Subject: Technical Team Meeting #7 (updated 12/20/2013; see item #5 on page 3)

Client: CDOT Region 1

Project: I-70 Peak Period Shoulder Lane

Meeting Date: November 18, 2013

### **SH 103 Interchange**

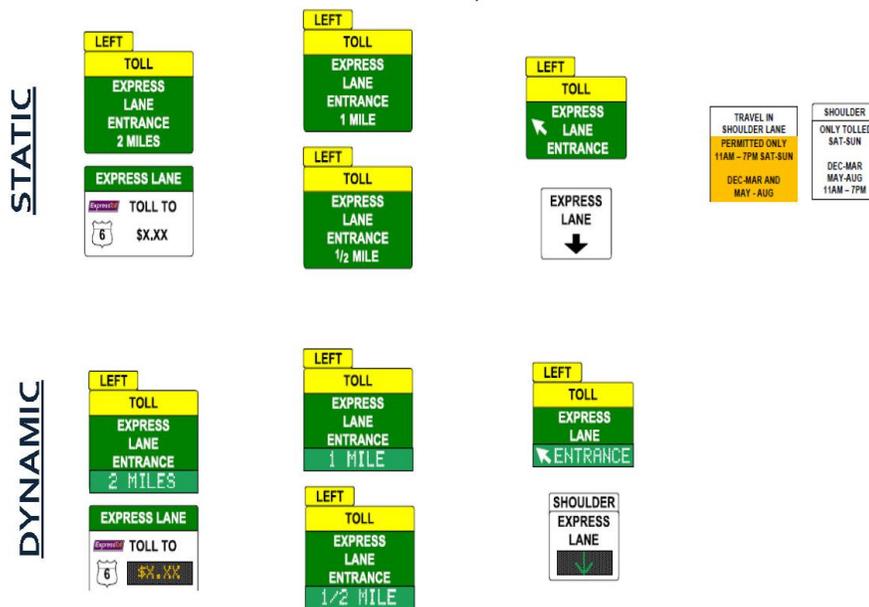
1. Discussion point is about the south versus north shift. Best to shift to the south, which impacts the water wheel park area, but we have determined some mitigation measures. Adding approximately 6 feet of impacts. Nothing changed on our overall analysis.

2. Want to get more input. Is everyone on the same page even if we add another 6 feet?
3. Will there be an impact that would cause CLOMR or LOMR? We are not 100 percent confident and will definitely look into that. Will do everything in our power to improve the park and improve the floodplain. It will be another month before we can make that determination.

5. Steve Yip asked if we can add the FHWA AASHTO standards to the table. Yes, we could clarify that.
6. Existing Bridge Modifications – The bridge currently has a sufficiency rating of about 60. Any modifications or repairs would look like “band-aids” and not be aesthetically pleasing. Increased risks during construction in working with an existing structure.

4. We are going to explore during the next meeting what that additional 6 feet does. We will have plans to show what that looks like. The shift will be from 6 feet to 12 feet. Pinch point is by the Water Wheel Park and we will show that in the plans. It will take creative solutions but we will get the park through there.

**LANE USE SIGNS (LUS)**

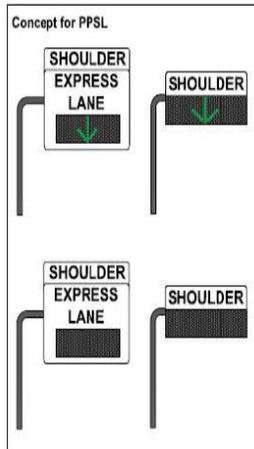
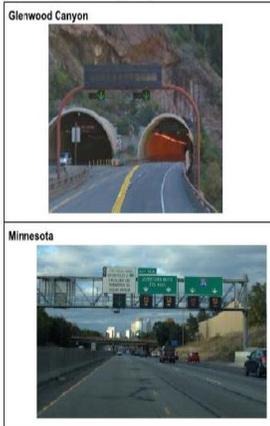
1. More variable message information.
2. For the middle sign, if the wording on the top of the sign could say “express lane” (rather than “shoulder”) when the arrow is green—that would be less confusing.

3. Wendy Koch suggested we could change it so that when you are on the lane, “shoulder” goes away and replaced with “express lane.”
4. Nicolena Johnson commented we can’t discuss signs without talking about ATM. She feels like we can’t design signage exclusively without ATM.
